T10/04-378r0 SAS-1.1 Clarification of SATA Signaling Level Specification

To: T10 Technical Committee  
From: Barry Olawsky, HP (barry.olawsky@hp.com)  
Date: 8 November 2004  
Subject: T10/04-378r0 SAS-1.1 Clarification of SATA Signaling Level Specification

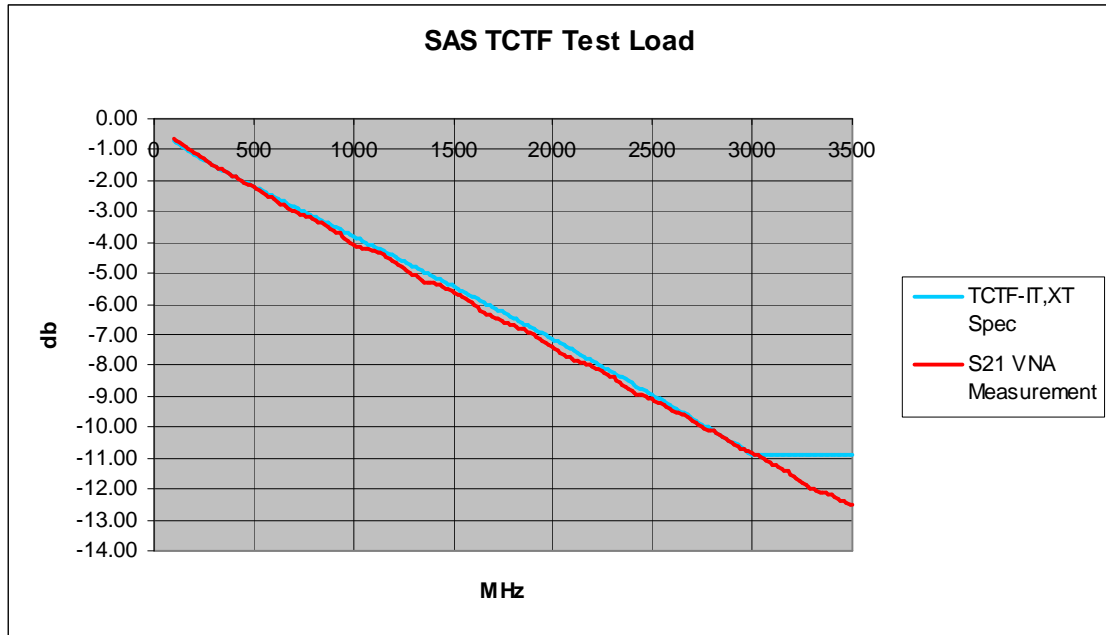
Add following note to table 30 referencing the 225mV cell in SATA column.

Worst case rise/fall time and jitter of SATA device may reduce amplitude at XR/IR point.
